# TECHNICAL SERVICE BULLETIN

<b>Subject</b>	PECL Fitting Replacement 40' FT
<b>Issue Date</b>	07/19/2023
<b>Service Bulletin Number</b>	SC-23-091
<b>Models Affected</b>	Service Specified Vehicles
<b>Complete By</b>	Next Service Opportunity
<b>Labor Operation Code</b>	CC66Z

This Technical Service Bulletin covers the procedure for replacing the Power Electronic Coolant Loop quick connect fittings with more durable brass fittings.

## Step 2:

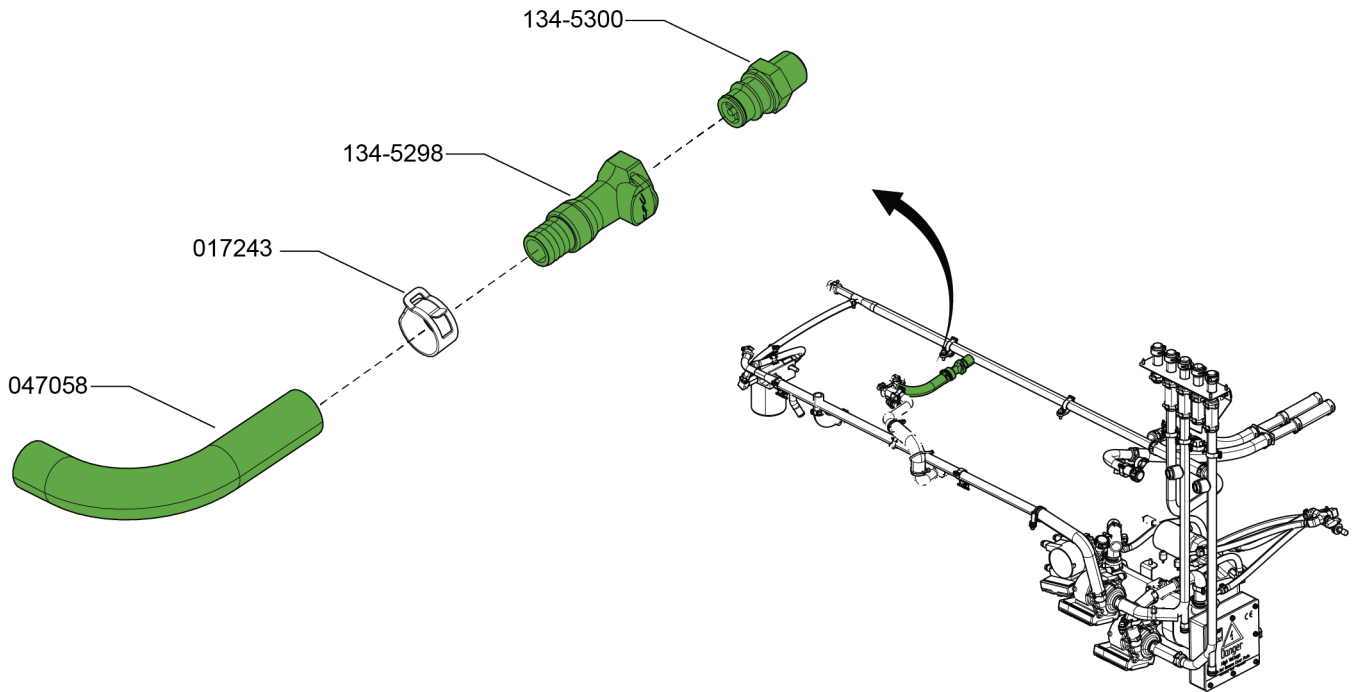
Loosen the worm-drive clamp and remove the quick connect fittings (134-5298 and 134-5300) and elbow hose (047058).

## Step 3:

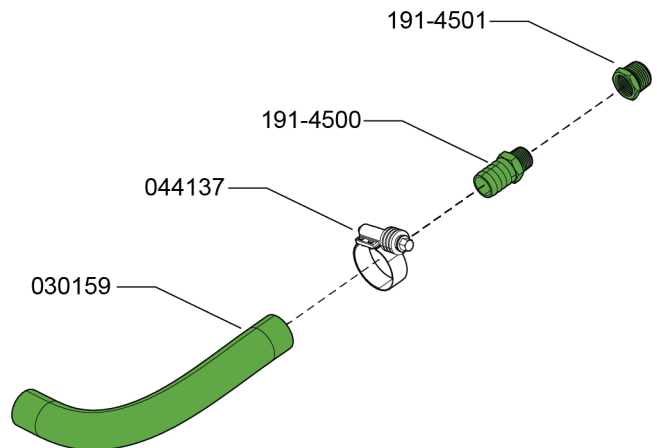
Wrap the threads of the new fittings (191-4500 and 191-4501) with Teflon tape and leave the last three threads exposed.

Install fitting 191-4501 into PECL hardline.

Thread fitting 191-4500 into 191-4501.

Attach replacement hose (030159) and secure with worm-drive clamp.
